Product Change Notification / LIAL-15PALA813

CCB 4979 Final Notice: Qualification of new stamped lead frame with inner lead tape and non-brown oxide treatment (BOT) for selected products available in 128L TQFP (14x14x1mm) package at MMT assembly site.

PCN #: LIAL-15PALA813

Lead frame comparison

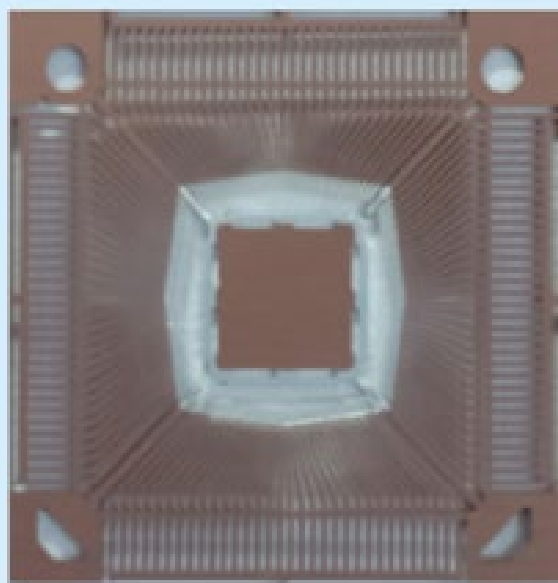
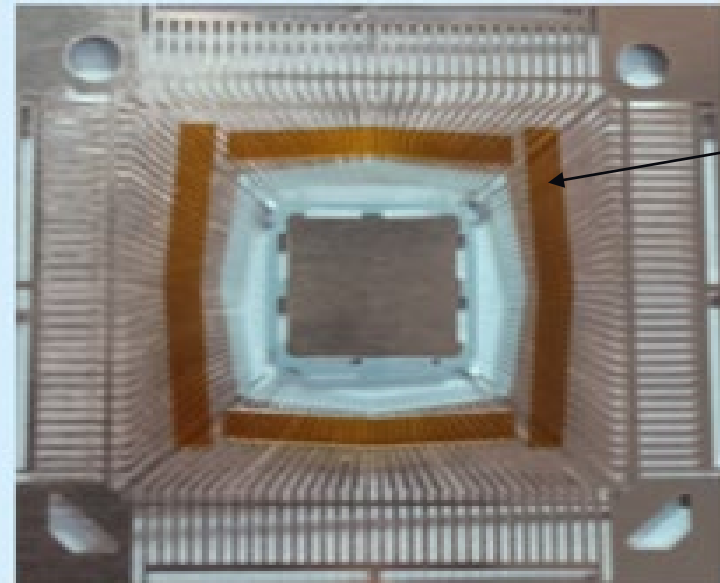
Pre Change

Stamp LF: BOT

Etched LF: BOT

Post Change

With inner lead tape

Stamp LF: Normal Cu+Inner tape
